**ISOVER Student Contest edition 2012
FAQ Version 1.0 / 08.11.2011**

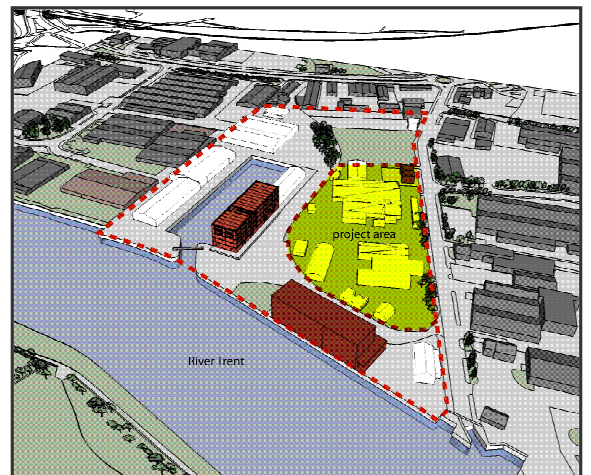
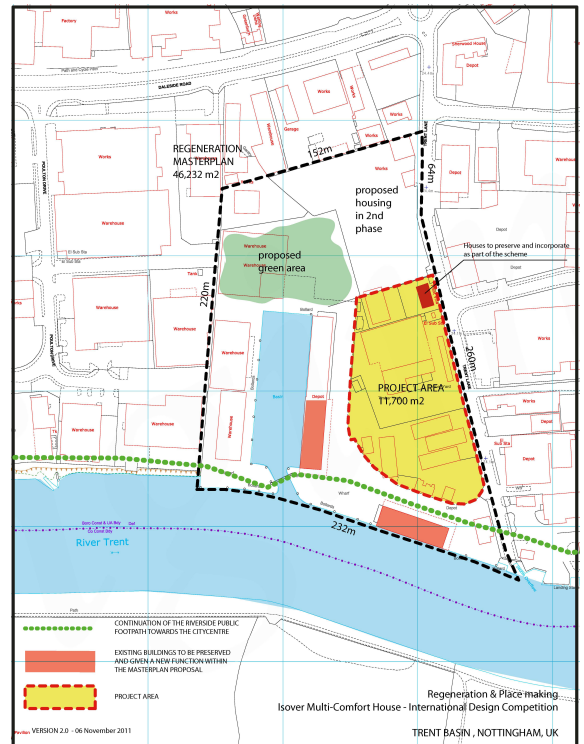
3. Which existing buildings should we keep?

In the 'Project area'

- The 2 Victorian houses in the NE corner marked in red will be kept and integrated to the residential proposal.
- All the other buildings in the project area will be demolished and replaced by new constructions.

In the remaining areas of the site there are several warehouses and depots. Based on the latest engineering report the recommendation is to:

- Keep the 2 depots marked in red. The two depots can be modified in order to respond to the participant's vision of the regeneration of the site.
- The rest of the warehouses and depot market in white will be demolished and can be replaced with functions that will respond to the authors ideas
